# PERMIT

SEWAGE DISPOSAL SYSTEM

MARYLAND STATE DEPARTMENT OF HEALTH

SUBDIVISION Gwenlee Estates

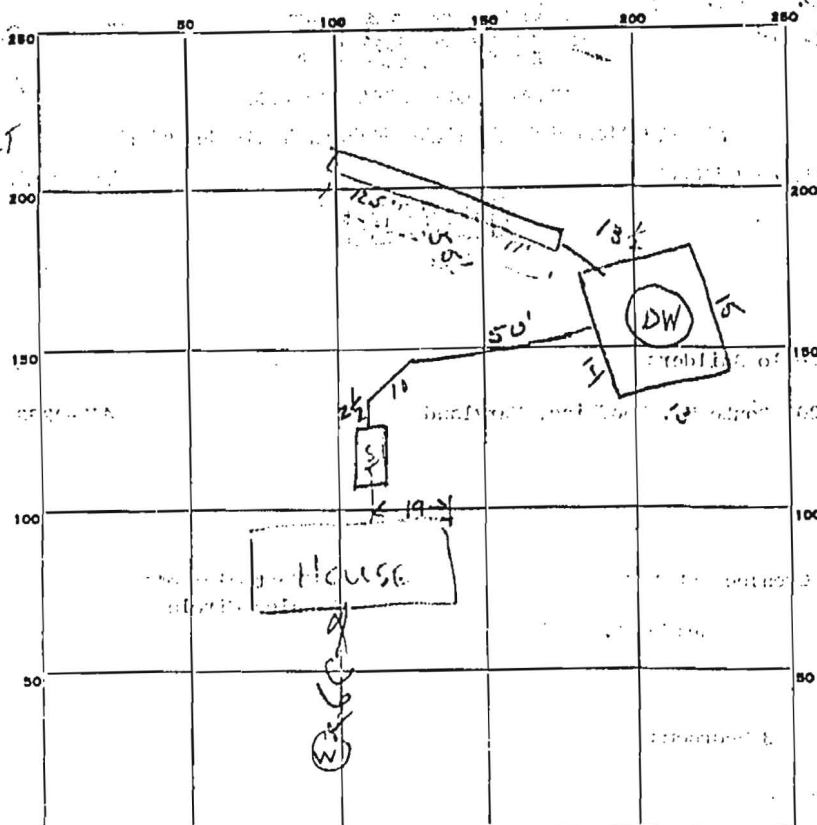
TOTAL AREA = 333 SQ. FT. + 270 TRENCH = 603 SQ. FT. TOTAL  
 2/24/76 R.H.

REMARKS 12/24/75 Inlet to DW @ 5 1/2' below orig. grade  
DW is 13' deep when spec called for 12' max depth  
Disc w DWM, install to raise inlet to 4 1/2', correct  
eff area to 11 1/2'; then will need trench 55' long 12'  
deep (ground slopes up) w 7" gravel under pipe.
